RE: **715, 719, 721 14th St NW**
Grading and Drainage Plan
Engineer's Stamp Date: 3/20/18
Drainage File: J13D208

Based on the information provided in your submittal received 3/21/18, the grading and drainage plan cannot be approved until the following are addressed:

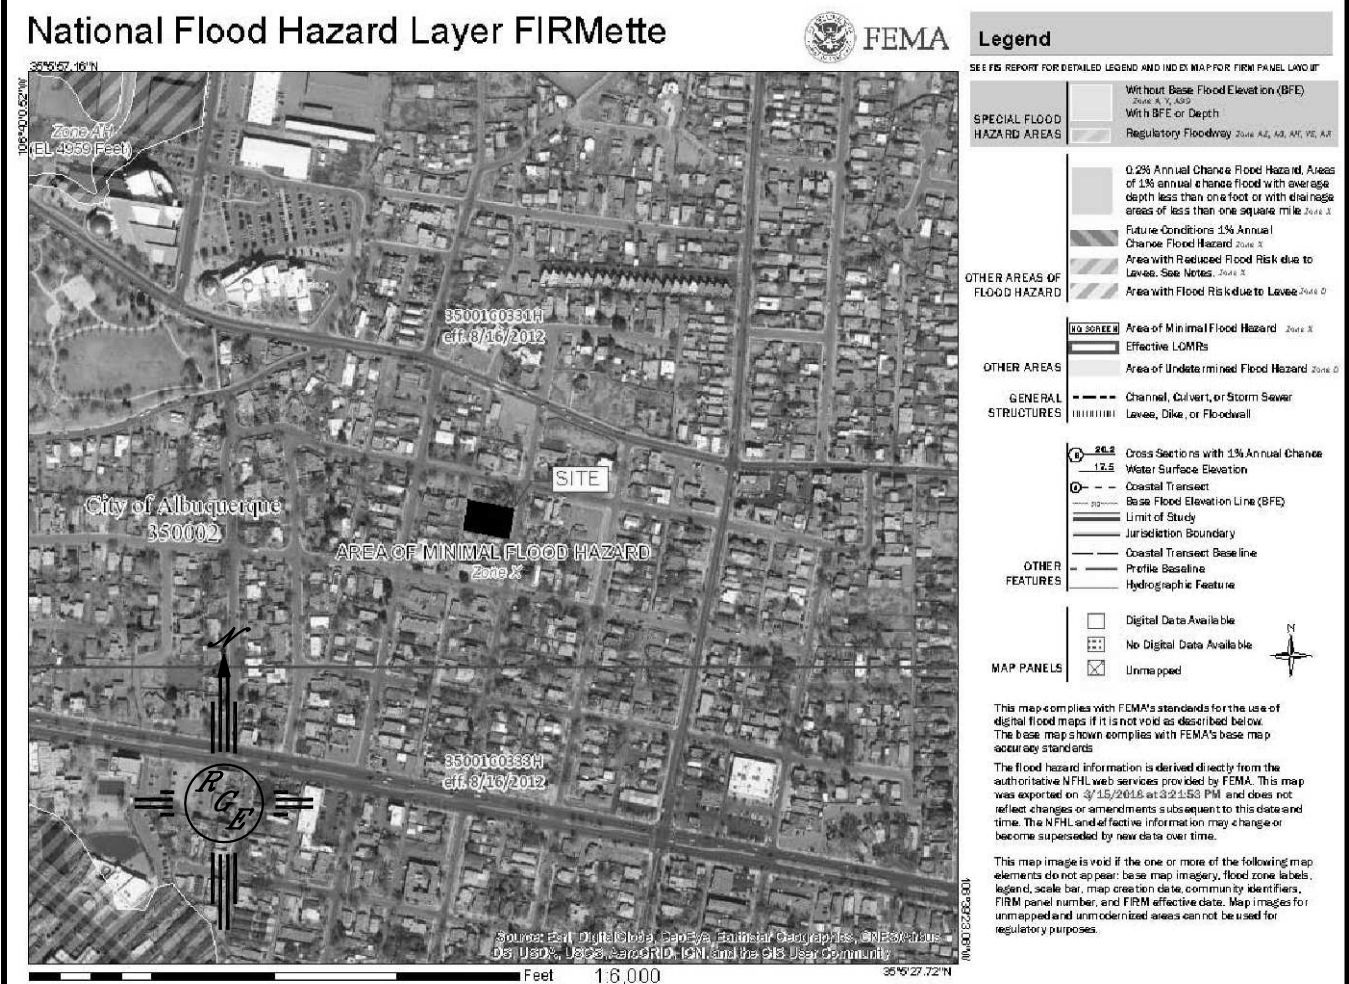
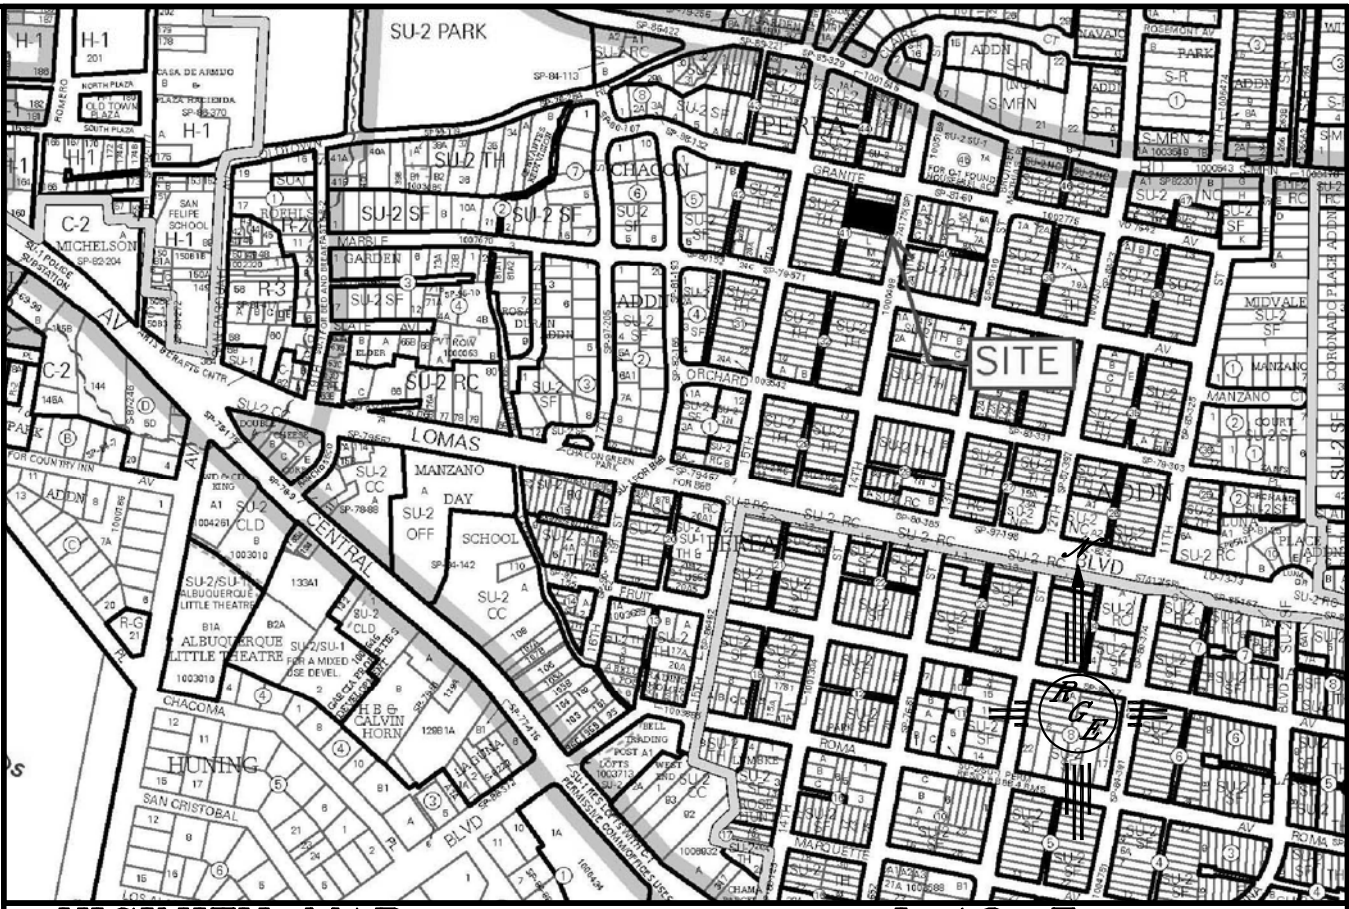
1. Provide onsite ponding volume on each lot for the 100-yr, 6hr volume.
2. Remove the language relating to first flush. Minor residential subdivisions (less than 10 units) and single residences are exempt from the requirement.
3. Provide all calculations on a stamped plan sheet or in a bound and stamped report; loose calculations cannot be accepted.

4. Pad Certifications will be required prior to Hydrology approving the residential Building Permits.

5. Engineer's Certification, per the DPM Checklist, will be required to ensure the ponds remained intact following home construction.
